SERVICE BULLETIN

Classification: EC97-027	Reference: NTB97-058	Date: August 13, 1997
-----------------------------	-------------------------	--------------------------

1995-97 MAXIMA SPARK KNOCK

Figure 1

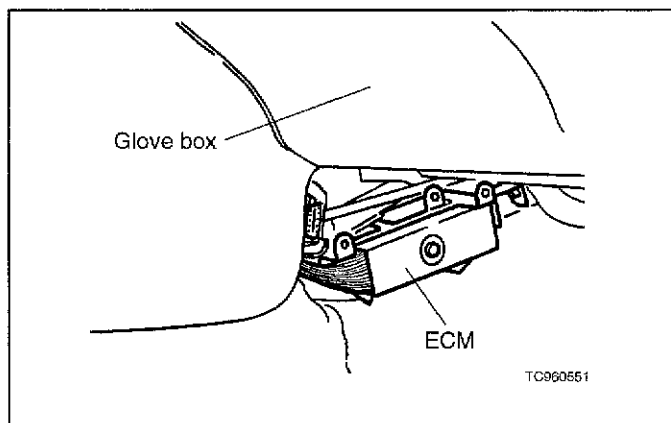
3. If the customer is using premium unleaded gasoline and the EGR system is operating normally, replace the ECM (see Figure 1) with the appropriate countermeasure part listed in the Parts Information table on page 2.
